Document ID: IK0900114

Title: Upper Radiator (Inlet) Hose Saddle Clamp Causing Leaks

Applies To: DuraStars and CE Buses with Cummins ISB

Figure 1: Old and new design of saddle clamp

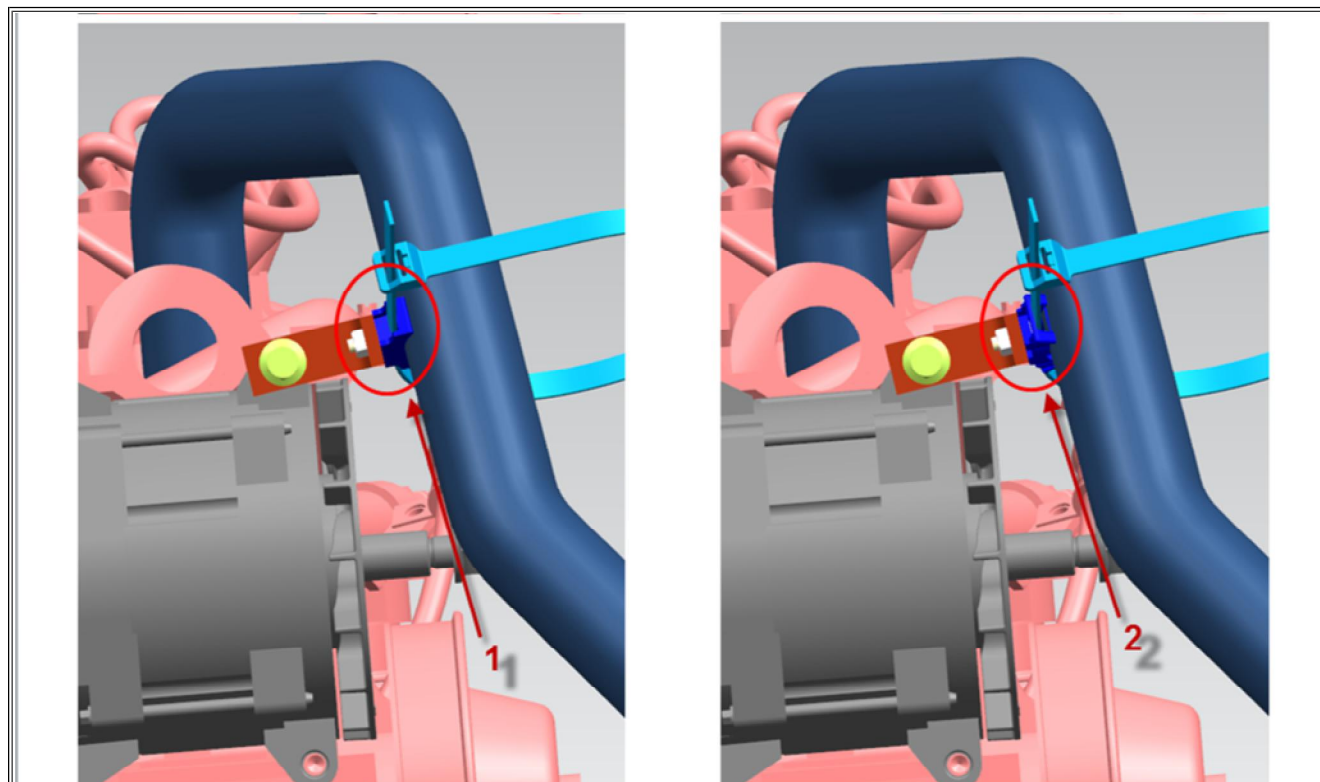
Visually inspect for rubbing/hose damage. See **Figures 1 and 2** for comparison of old and new saddle clamp design. If the hose is punctured and the saddle clamps are the old design, replace hose and replace saddle clamps with new design.

Item 1: Old design - P/N 2041341C1

Item 2: New design - P/N 4039319C1

Figure 2: Old and new design of saddle clamp

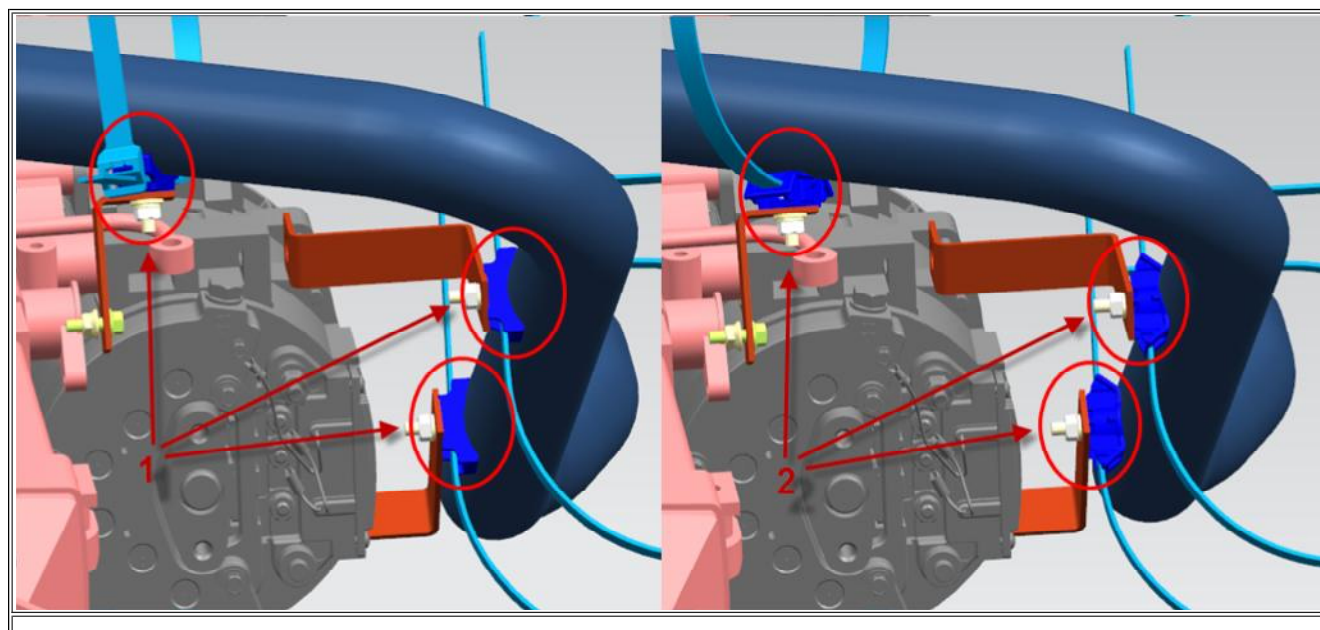
Item 1: Old design - P/N 2041341C1
Item 2: New design - P/N 4039319C1

**Figure 3: Engineering specifications for saddle clamp and extension bracket**

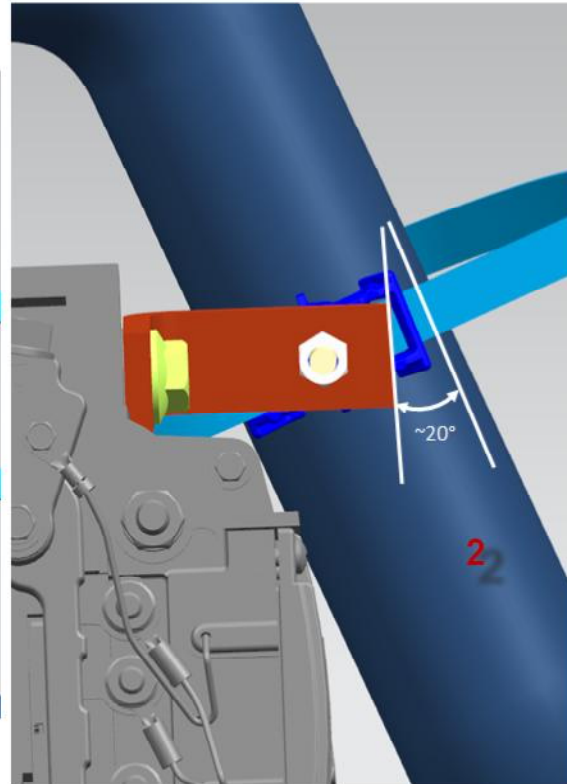
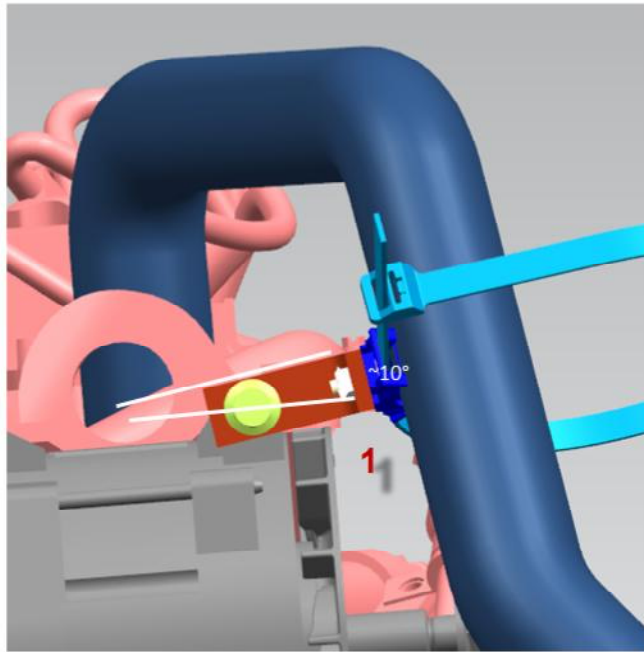
1. Remove old zip straps and saddle clamps.
2. Replace upper radiator hose.
3. Install new saddle clamp and zip strap, as shown in **Figure 3**. The angle of both the extension bracket and the saddle clamp in relation to the bracket must be correct, otherwise rubbing can occur.

Item 1: Extension bracket angled up from parallel $\sim 10^\circ$.
Item 2: Saddle clamp angled $\sim 20^\circ$ up from parallel. Axis of saddle should align with axis of hose.
